**EAST GOSHEN TOWNSHIP
PLANNING COMMISSION
Meeting Agenda
Wednesday, February 1, 2017
7:00 PM**

SUBDIVISION AND LAND DEVELOPMENT PLAN
(PRELIMINARY/FINAL) FOR
BRAKMAN PROPERTY

PCSM NON-STRUCTURAL BMP PLAN

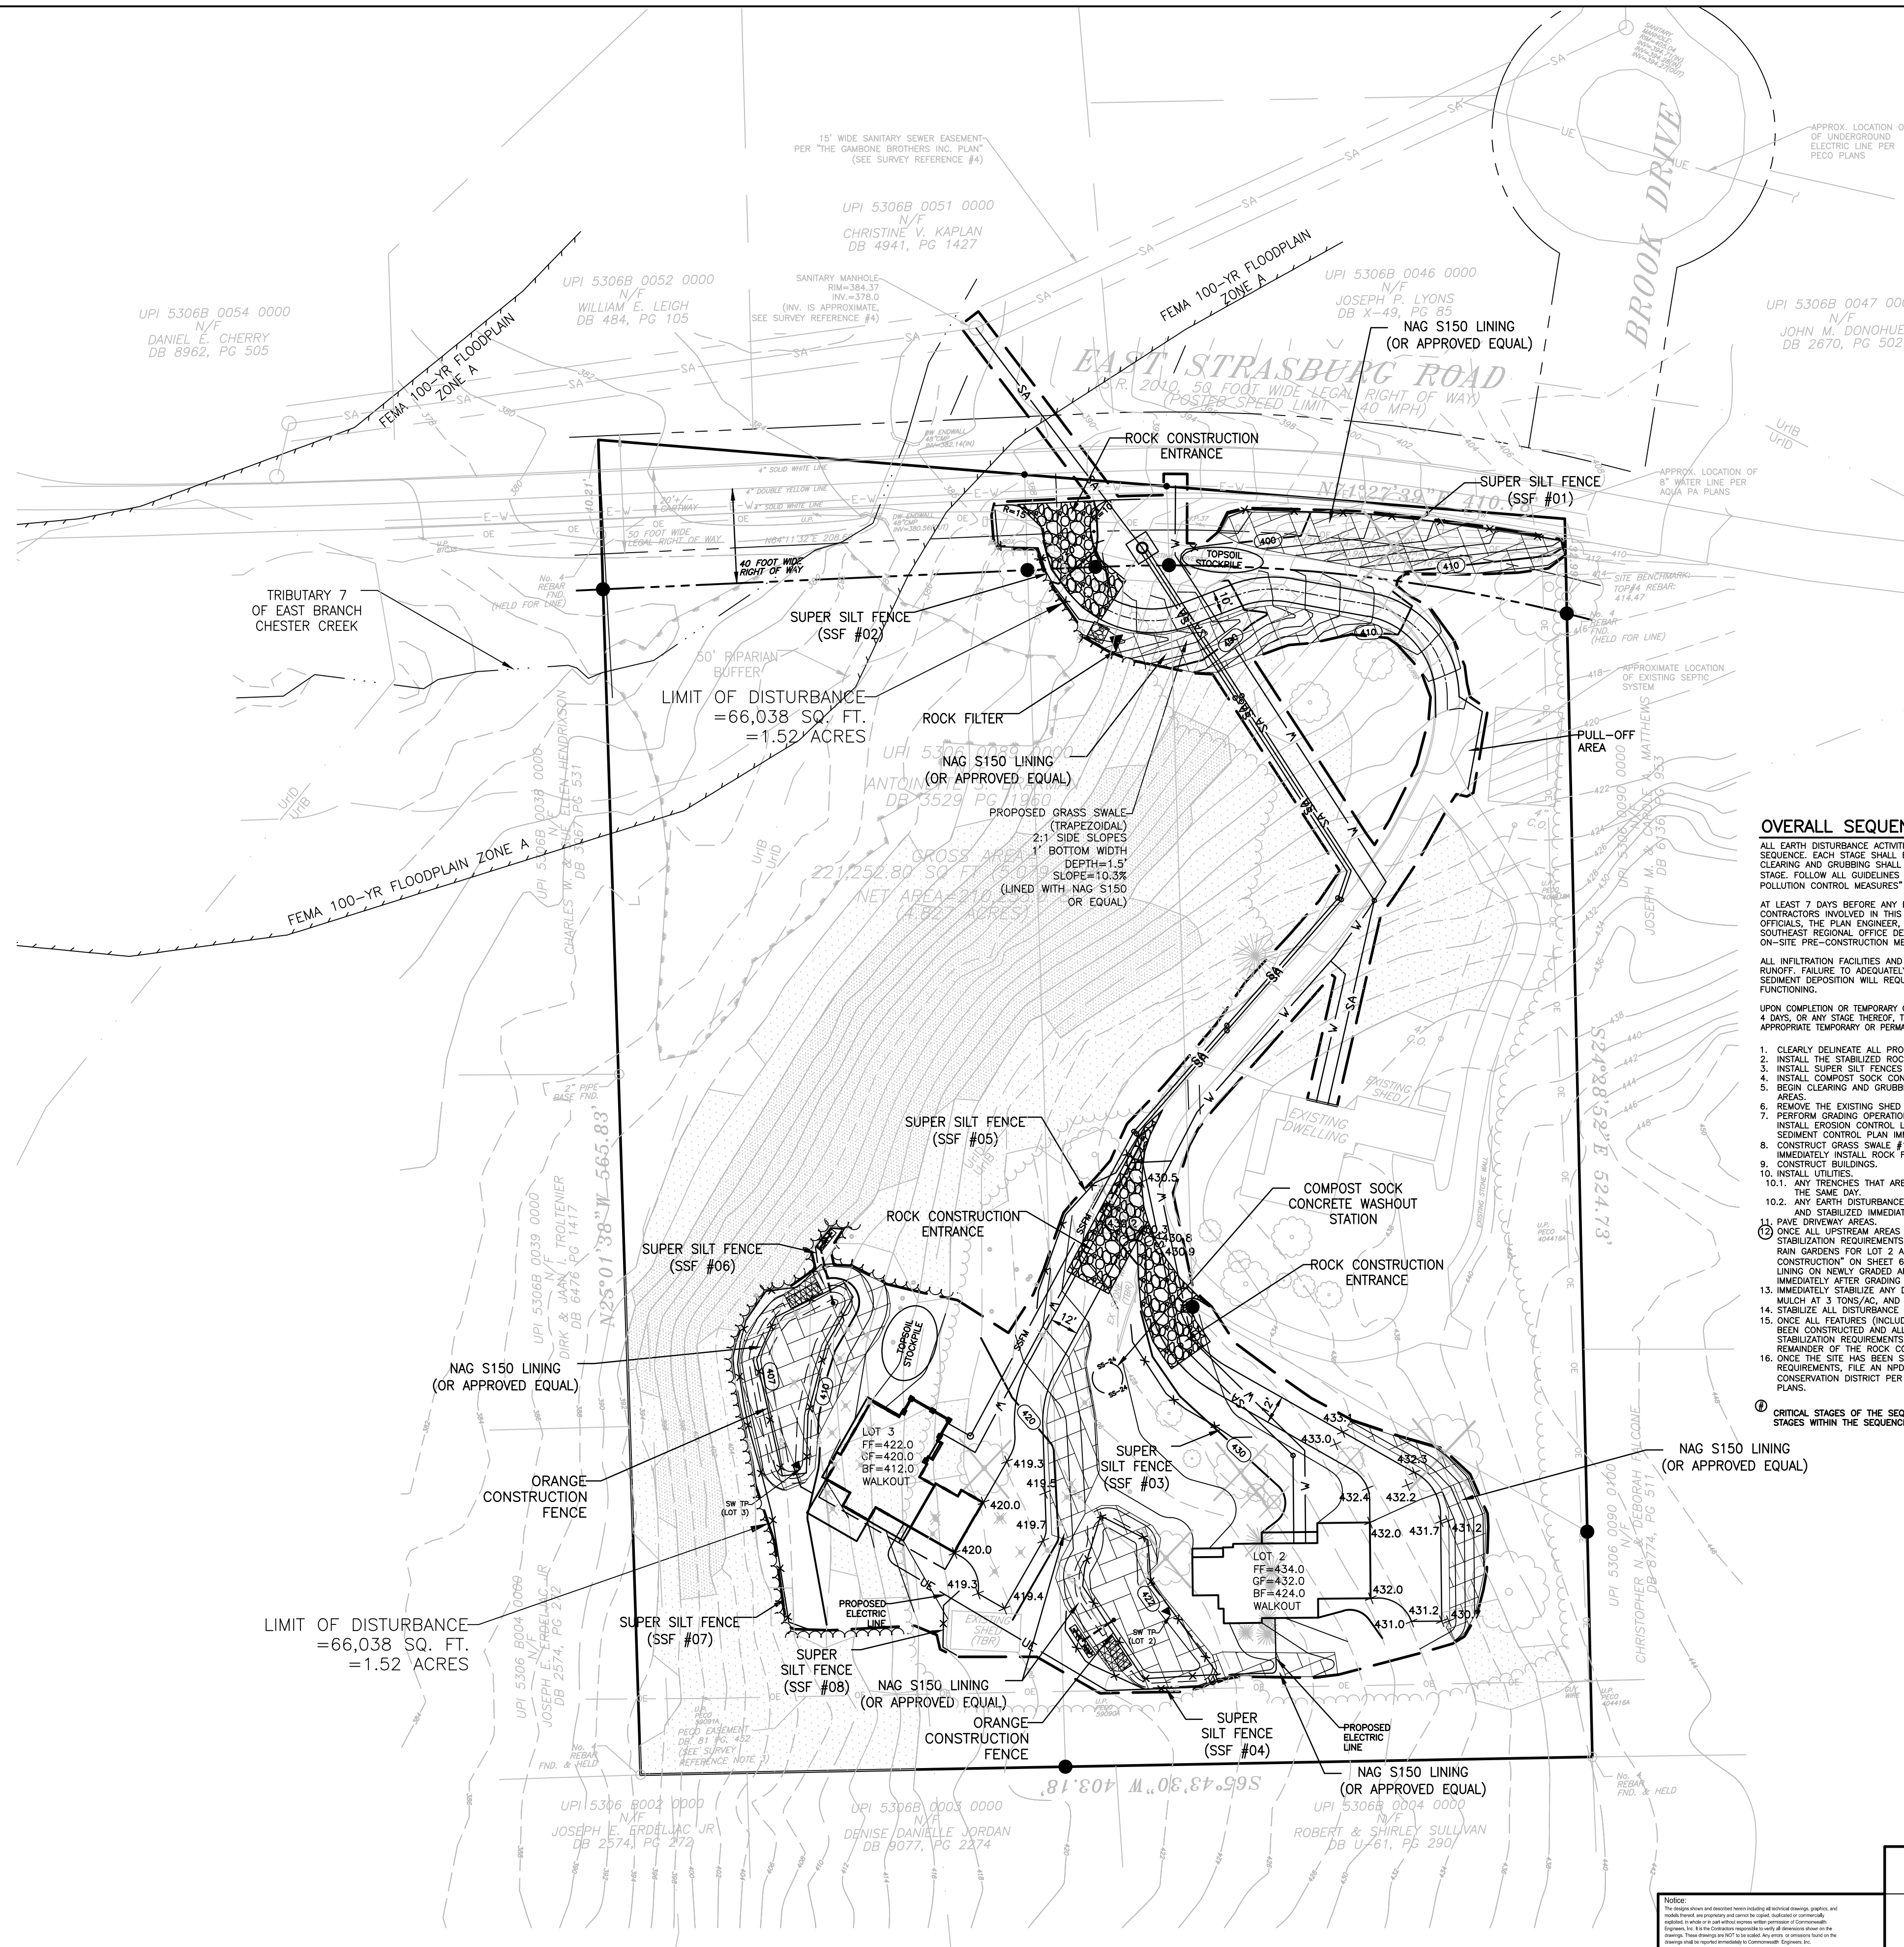
5. Rooftop Disconnection is no longer being used as a credit toward the non-structural BMP calculations. Sheet 5 and the PCSM Report have been revised accordingly. Also note that now only one roof drain collection piping system is being proposed (to divert roof drainage of the south side of the Lot 3 house to the rain garden).

6. The amount of impervious area being considered for credit has been revised as shown on Sheet 5. The PCSM report has been revised accordingly.
7. *Per §195-24.B, one foot of freeboard is required above the maximum pool elevation computed when the facility functions for the one-hundred-year proposed conditions inflow. Pages 66 and 67 of the narrative indicate that only 0.35 feet and 0.33 feet are provided for the Lot 2 and Lot 3 rain gardens, respectively.*
